Re: Comments on Report for HDD PA-CH-0127.0000-RD (HDD# S3-0320)

Pursuant to the Corrected Stipulated Order entered on EHB Docket No. 2017-009-L on August 10, 2017 (“Order”), and on behalf of Clean Air Council, Mountain Watershed Association, Inc., and the Delaware Riverkeeper Network (“Appellants”), please accept these comments on Sunoco Pipeline L.P.’s (“Sunoco”) re-evaluation report (“Report”) for the horizontal directional drilling (“HDD”) indicated by drawing number PA-CH-0127.0000-RD (the “HDD Site”).

Figure 1 Graph of RQD Results by Depth (bgs)
 (higher RQD appears to correlate with depth at this site)

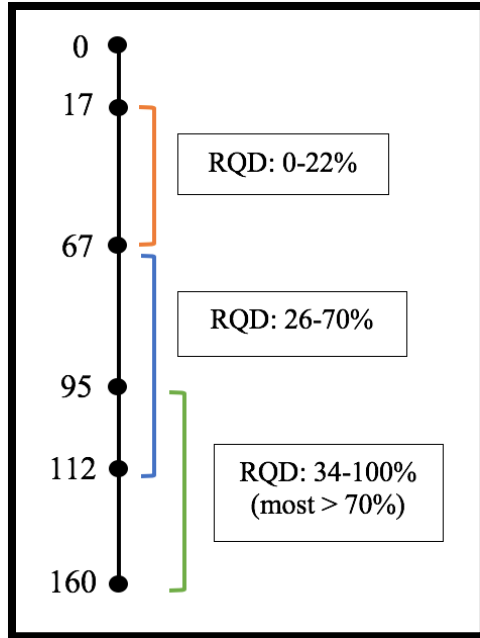
3. Sunoco needs to justify the depth of the redesigned profile.

Although Sunoco’s redesign of for the Site includes deepening the drilling profile, Sunoco has not explained why it has chosen the specific depth it proposes to pass through, or why that depth is preferable to any other depth. At this Site, deeper depths appear to correlate with higher rock integrity with some variability. See Figure 1 Graph of RQD Results by Depth (below). Drilling deeper to access the higher quality and more granite-like material could be a good strategy to avoid inadvertent returns, LOC, and another abandoned pilot hole so long as the appropriate depth is chosen. The Department should require Sunoco to justify the depth of its redesigned profile by contrasting it with the possibility of drilling at other depths.
